SEAT Cordoba (6L2) / Ibiza IV (6L1)

Skoda Fabia (6Y2, 6Y3, 6Y5)

Volkswagen Fox (5Z1, 5Z3) / Polo (9N)

Fig. 1: GMT 29710 01

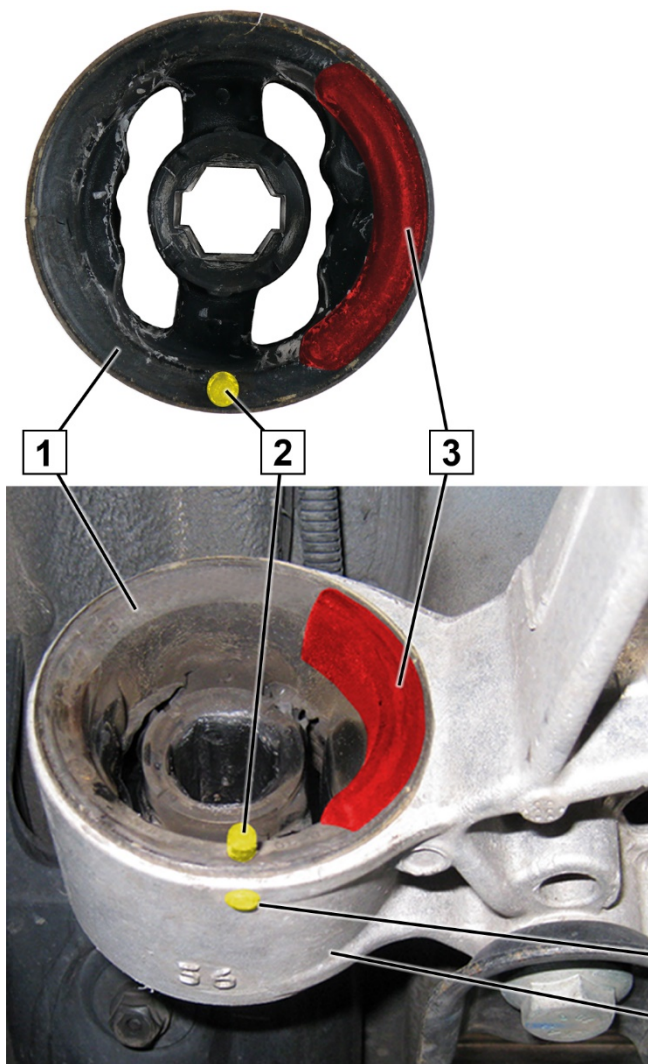
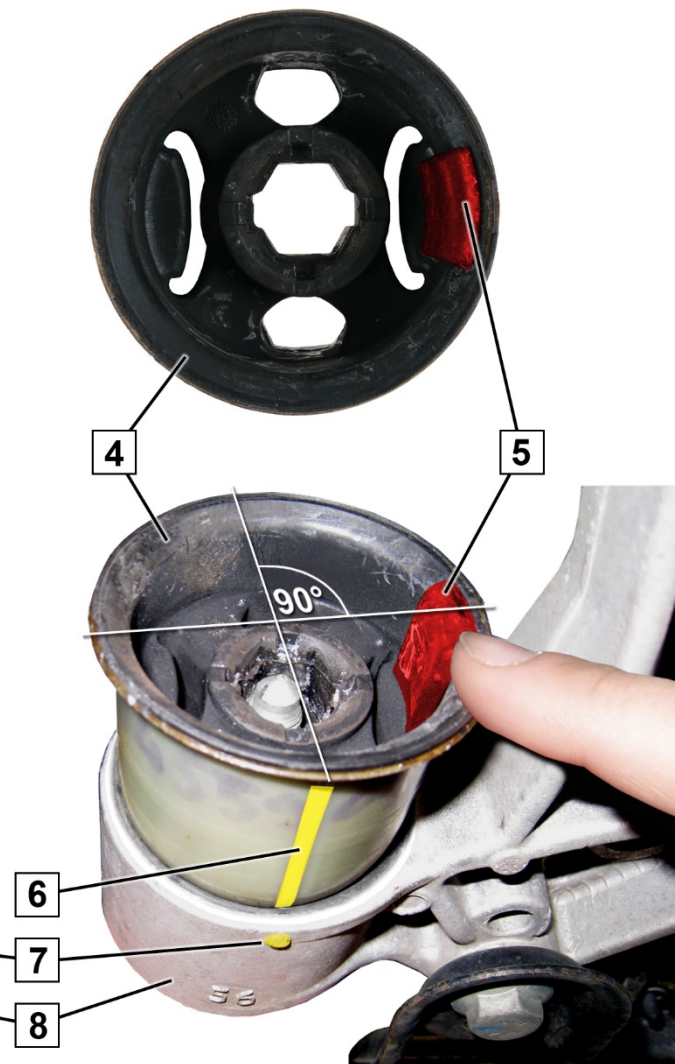
Always replace rubber-to-metal components (GMT) in pairs.
The modified GMT (4) replaces GMT (1).

1. Mark the GMT (4), as shown in Fig. 2 (6).
2. The contact surface for the control arm (5) must point to the axle support (8) or towards the center of the vehicle
3. The mark (6) must align with the mark on the axle support (7).
4. In this position, press the GMT (4) into the axle support (8) using a suitable tool.

The mark on the axle support (7) is cast below on the right side of the vehicle (Fig. 1, 2) and above on the left side of the vehicle.
